Re: Indian Point Unit No. 2  
Docket No. 50-247  
NL-02-063

SUBJECT: Updated Replacement Pages of Technical Specifications for License Amendment Request (LAR 01-010) Regarding Spent Fuel Storage Pit Rack Criticality Analysis with Soluble Boron Credit, Indian Point Energy Center, Unit No. 2 (TAC No. MB2989)

**ATTACHMENT TO NL-02-063**

ATTACHMENT TO LICENSE AMENDMENT NO.

Figure 3.8-1  
Spent Fuel Storage Rack Layout

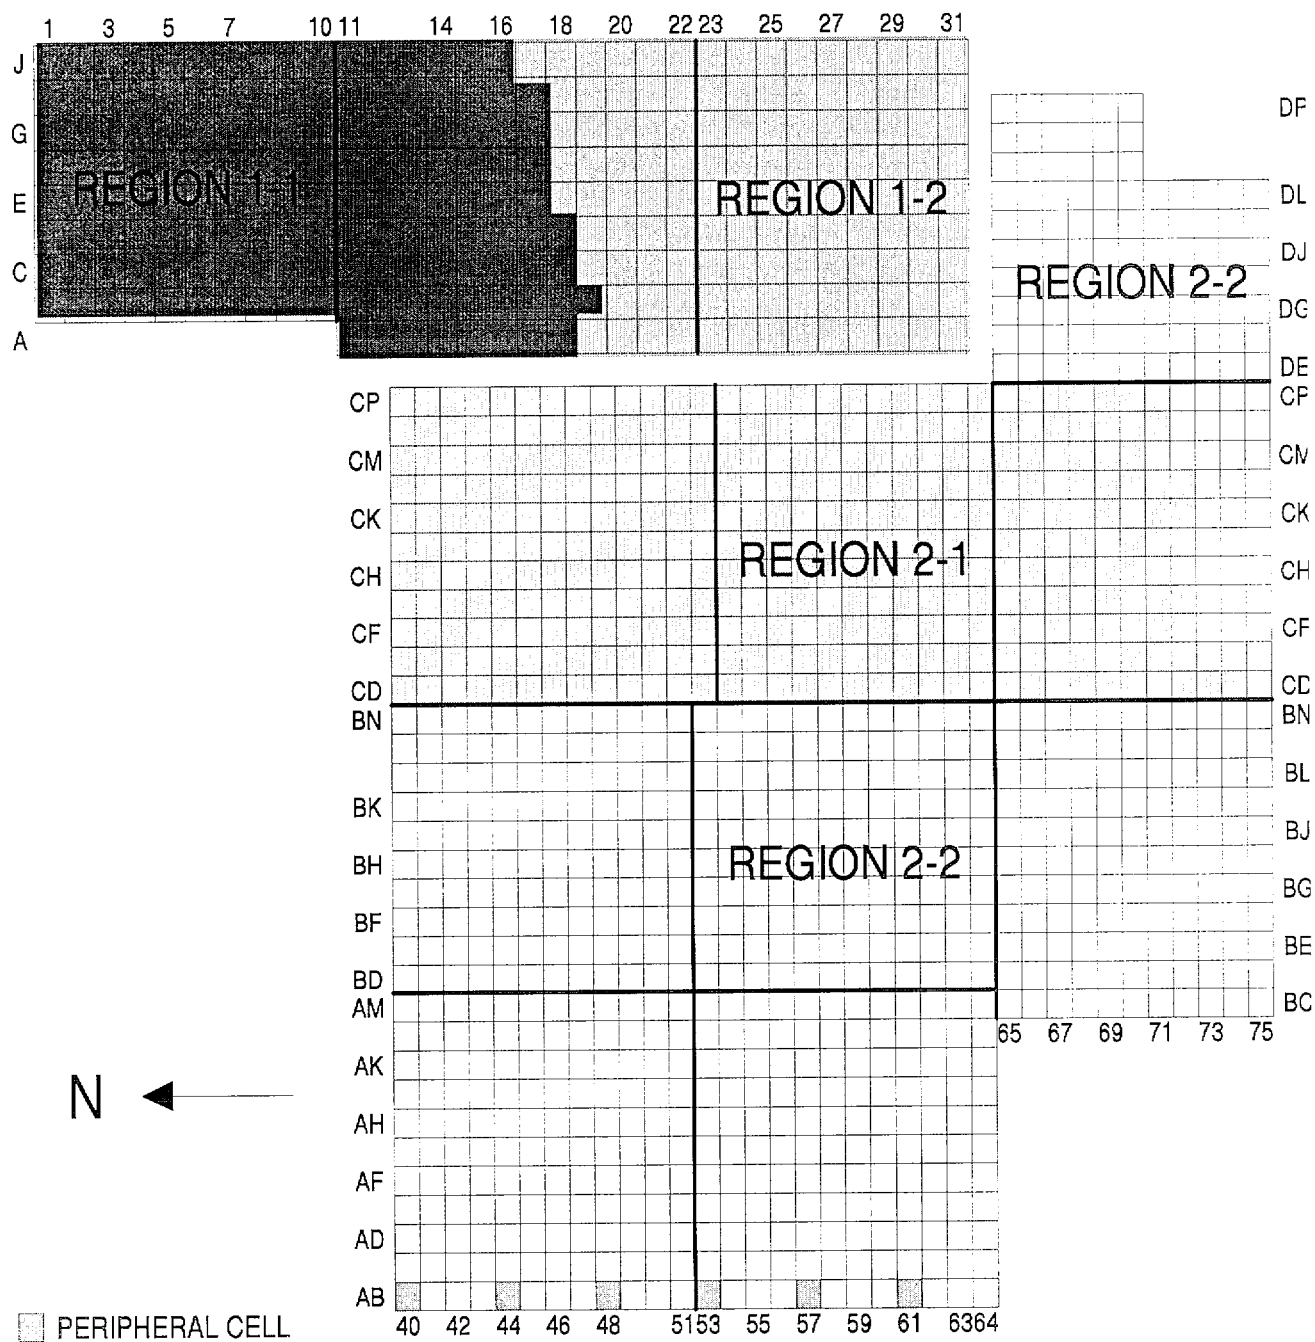
1. The spent fuel racks are categorized as either Region 1-1, 1-2, 2-1, or 2-2 as specified in Figure 3.8-1. Fuel assemblies to be stored in the spent fuel storage racks are qualified based on burnup, enrichment, and cooling time as specified in Figures 3.8-2 through 3.8-5.

- c. Storage of fuel in Region 2-1 is restricted to assemblies that meet the burnup criteria in Figure 3.8-4.
  - d. Storage of fuel in Region 2-2 is restricted to assemblies that meet the burnup criteria in Figure 3.8-5. Fuel that meets the criteria for Region 2-1 may be stored in Region 2-2 in "peripheral" cells. As shown in Figure 3.8-1, the peripheral cells are located along the west wall and are separated by at least 3 cells.

**Figure 3.8-2**  
**Region 1-1 - Limiting Burnup versus Initial Enrichment**

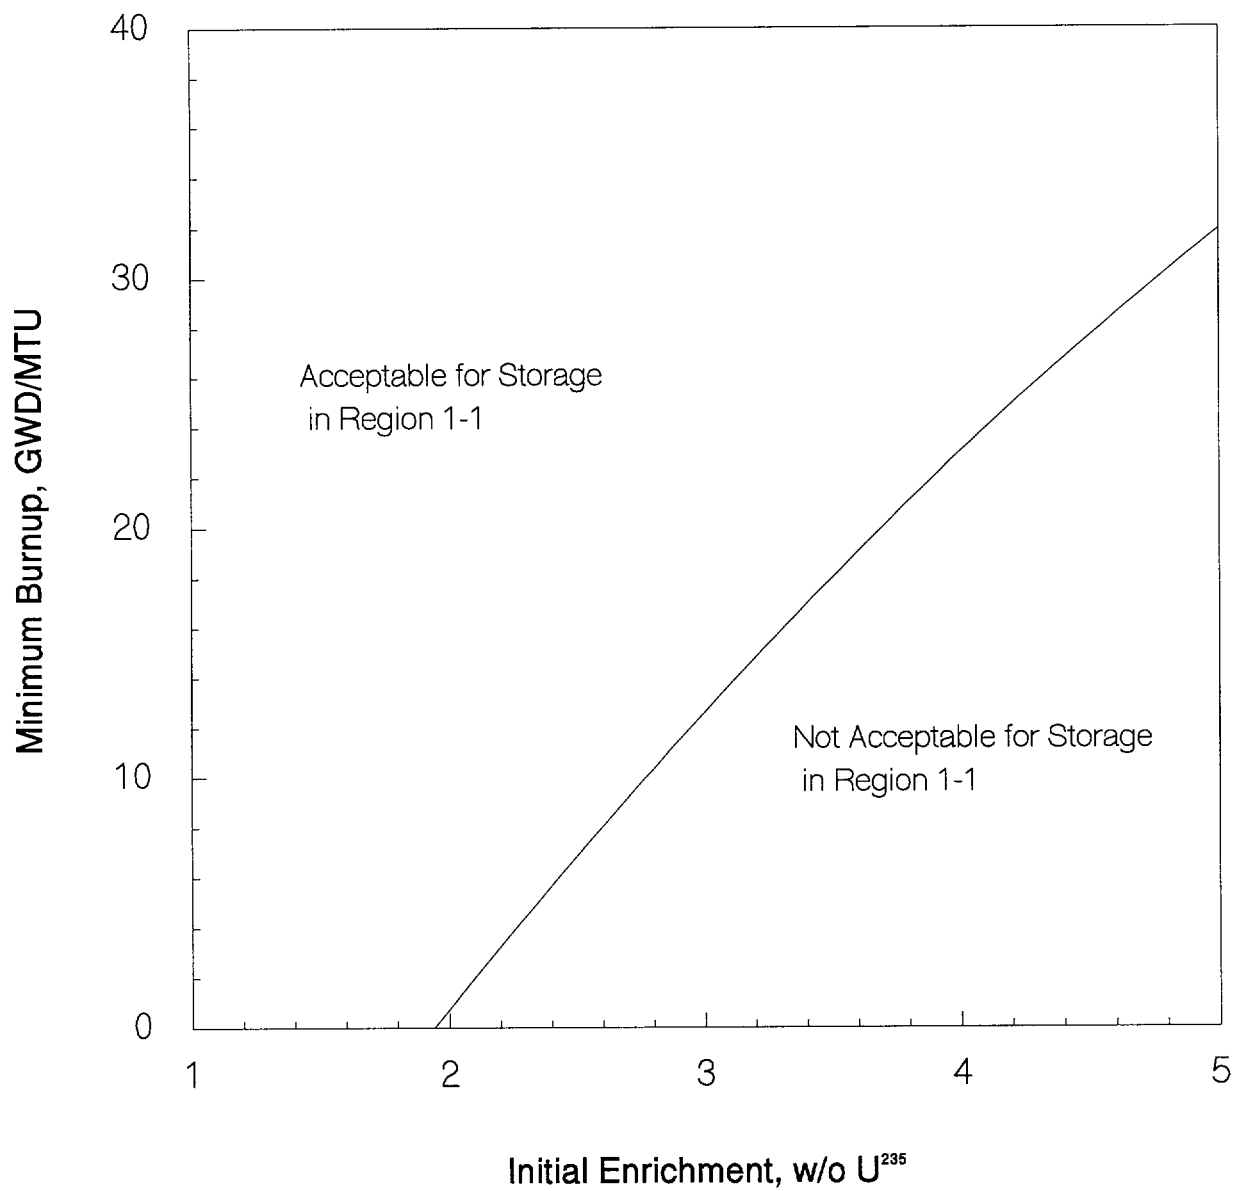
- a. Storage of fuel in Region 1-1 is restricted to assemblies that meet the burnup criteria in Figure 3.8-2.
  - b. Storage of fuel in Region 1-2 is restricted to assemblies with enrichments  $\leq 4.5$  weight percent ( $\text{w/o}$ ) or  $< 5.0$   $\text{w/o}$  with a minimum number of Integral Fuel Burnable Absorbers (IFBA) rods as specified in Figure 3.8-3. Fuel that meets the criteria for Region 1-2 may be stored in Region 1-1 in a checkerboard (1 out of 2 cells with every other cell left vacant) loading configuration.
